**Site-Specific Environmental  
Authority**

**Petroleum Lease (PL) (1058)  
Bearcat**

**Response to Notice of  
Information Request**

**Figure 1: PL 1058 - HES and GES Mapped Wetlands**

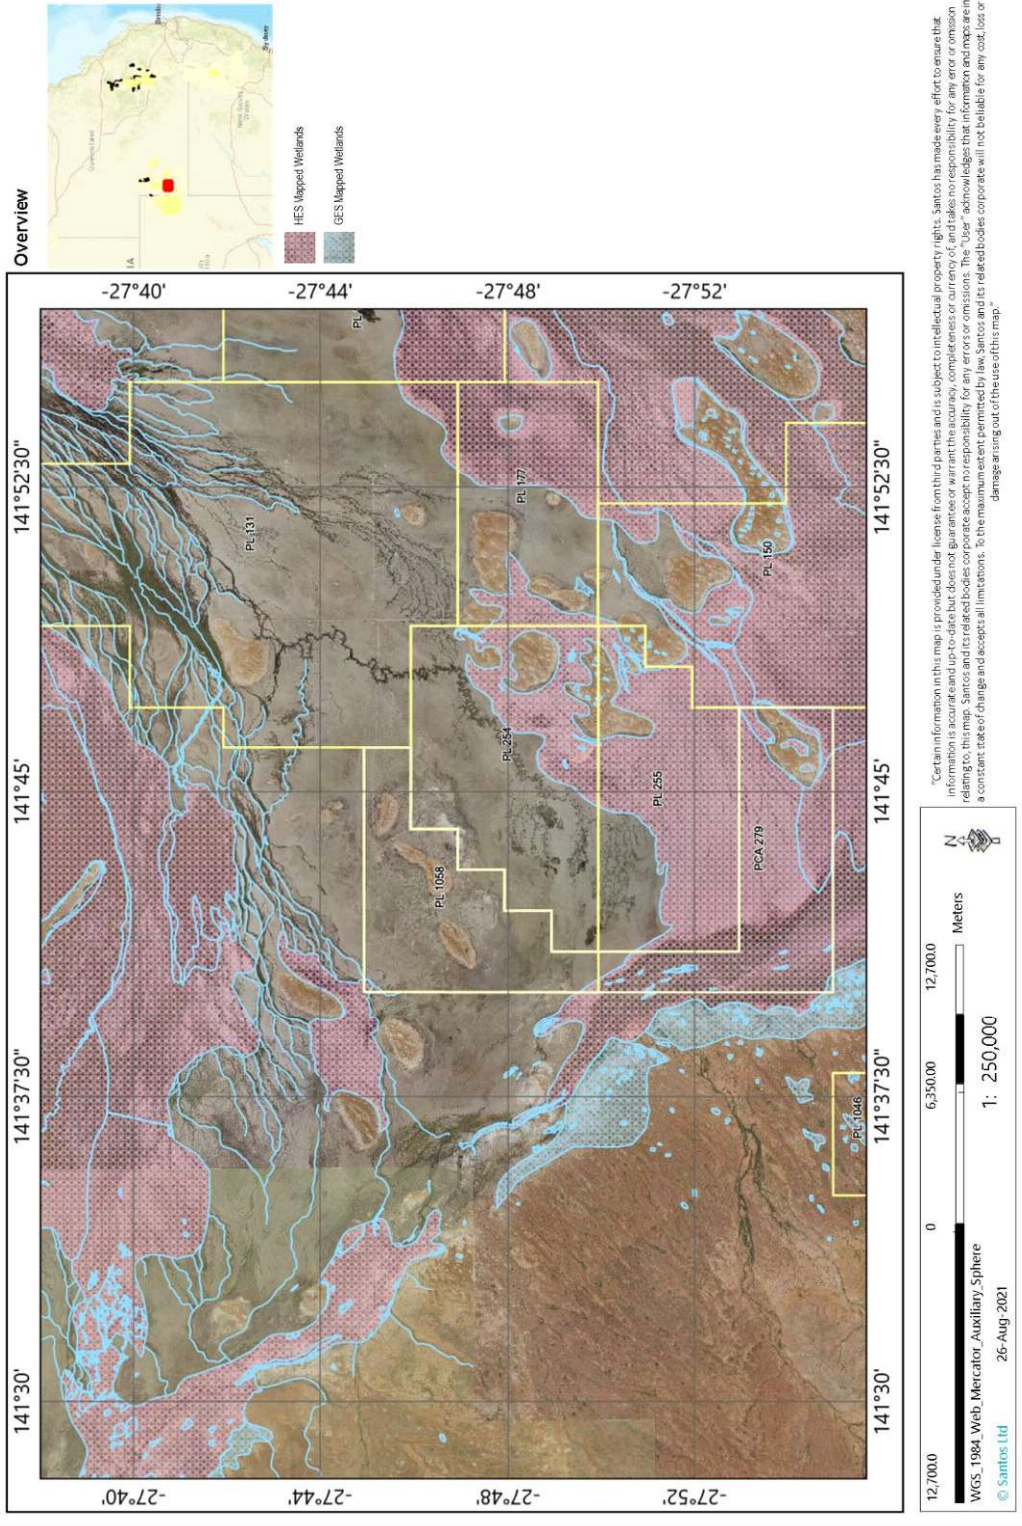
- l. Table 6-6 provides an impact assessment of PL 1058 MSES for wetlands and watercourses. In response to the criteria states "... areas of the wetland or watercourse being destroyed or artificially modified". The response also states that this is "unlikely." However, 0.9ha of wetland is proposed to be cleared, suggesting that an area of the wetland will be destroyed. It is also not confirmed when revegetation of the area will be guaranteed suggesting that the area will be modified, and for an unknown period.*

*A reassessment of this criteria in Table 6-6 is required that directly addresses whether the proposed activities are destroying or artificially modifying the landscape. Note: Rehabilitation and timing is not a prompted consideration in the SRI guideline, therefore is not relevant to the criteria.*

### **Santos Response to Element 7I**

HES wetlands intersected by PL 1058 are located at the far north-western and south-western tenure boundaries. Only 0.7 % (35.9 ha) of PL 1058 is mapped as a HES wetland. These small HES wetland areas are connected to a significantly broader area of HES (and GES) mapped wetland in the surrounding region (refer to Figure 1 below). This broader area is essentially one large intermittently flooded wetland system i.e. the Cooper Creek drainage basin wetland area. To provide context, there is more than 100,000 ha of interconnected HES wetland mapped within 30 km of PL 1058. The HES wetlands mapped in PL 1058 are not isolated confined wetlands, but rather minor areas of a significantly larger interconnected wetland system (floodplain).

As part of the proposed activities in PL 1058, Santos conservatively estimates 0.9 ha of vegetation located in a HES wetland will require clearing. The clearing of an area of vegetation within a wetland will not necessarily result in the environmental values of the wetland being “destroyed or artificially modified” as the activities are not substantial enough to impact the function of the wetland, particularly given implementation of proposed EA conditions and other mitigation measures outlined in the application. Further, as discussed in the application, proposed petroleum activities will be scheduled to be completed when no surface water is expected to be present within the PL, and outside of flood events/inundation periods.

Clearing up to 0.9 ha of vegetation in the HES wetland in PL 1058 is unlikely to result in:

- a) any of the wetland environmental values listed above from being significantly or substantially negatively affected (given implementation of proposed EA conditions and the mitigation measures discussed in the application); and
- b) the Cooper Creek wetland being "destroyed" or "artificially modified".
